CITY OF PORTLAND, MAINE

AGENDA PORTLAND PLANNING BOARD MEETING

Memorandum Planning and Urban Development Department Planning Division

To: Brandon Mazer, Chair and Members of the Portland Planning Board
From: Andrew Tufts, Planner
Date: October 16, 2020
Re: 5 Portland Street, Preble Street
Project #: CU-001231-2020 CBL: 033 L004
Meeting: October 20, 2020

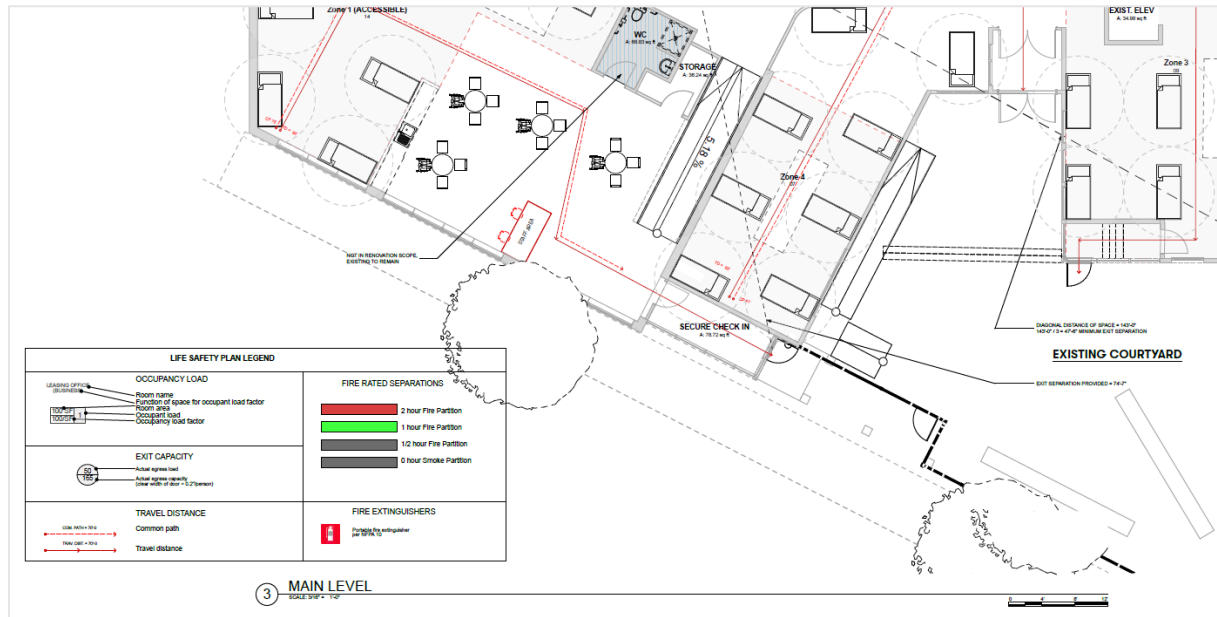
Staff concurs that the addition of fencing into the site and program will improve delineation of Preble Street operations from the previous condition. Optimal plans for loading, deliveries, trash or waste generation is still under review. Further information is still needed to fully address loading and deliveries.

Applicant Response: The proposed project will decrease impact on the surrounding properties. The current day shelter and emergency temp. overnight shelter has exterior space open to the corner of Preble Street and Portland Street. This open courtyard often crowds with people throughout the day and evening. The new emergency wellness shelter has the opportunity to work with smaller groups giving the homeless a better chance to recovery. The new fencing will act as a screening for those wanting to be outside during the day and evening during their stay with Preble Street. This facility will provide adequate space and support for the homeless individuals staying there. The new screening fence will have a positive impact in the neighborhood.

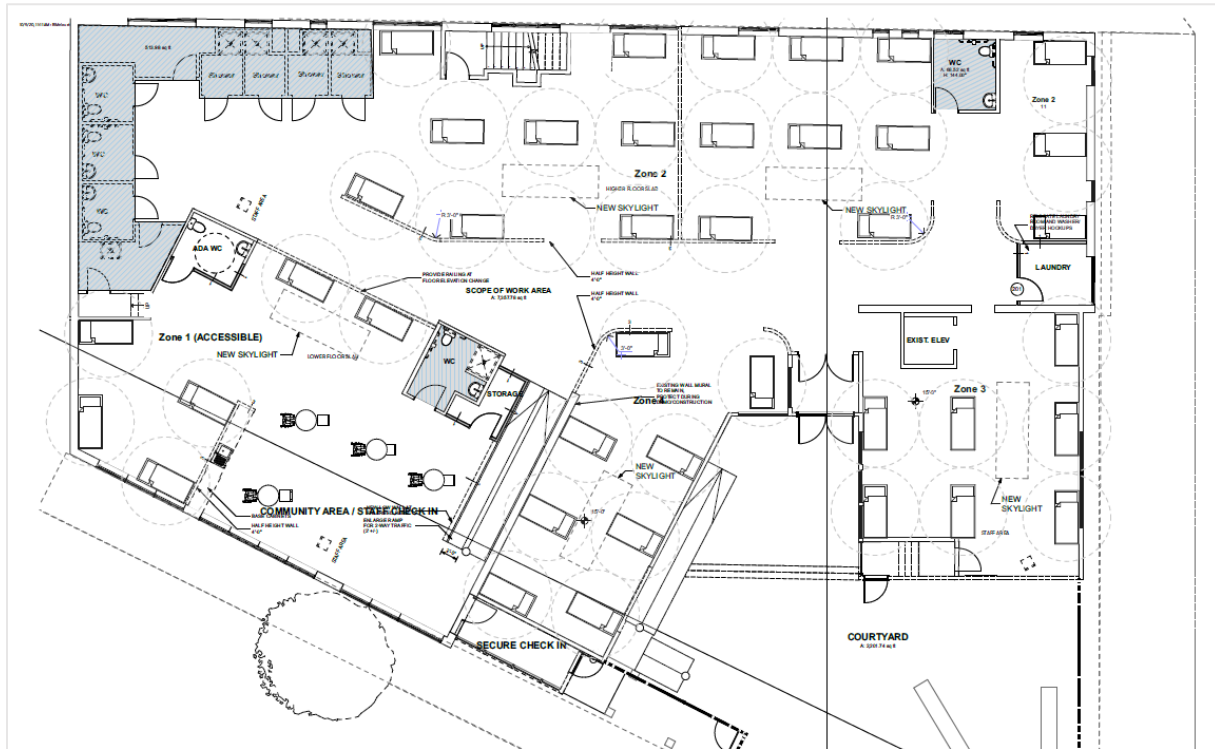
The design of the shelter's interior creates a large, open area with beds spaced 8-feet apart, all within sightlines of staff areas. Staff areas have been marked on the floor plan with sight lines to all sleeping areas. See floor plan above.

The primary entrance to the facility would be located on Portland Street, to the west of the courtyard. There would be a duo door system that controls shelter access to provide assessments, safety and security. The first unlocked door would allow the client to come into the building out of the elements, leading to a vestibule. The second door would be locked and lead to a staffed front desk in the main lobby. Anyone entering the main lobby would have to be admitted by Preble Street staff. Wellness screening would also take place at this time including hand cleansing, taking temperature and other COVID-19 protocols. The 40-bed shelter would house mostly the same individuals nightly, using the same beds, eliminating the need for lines.
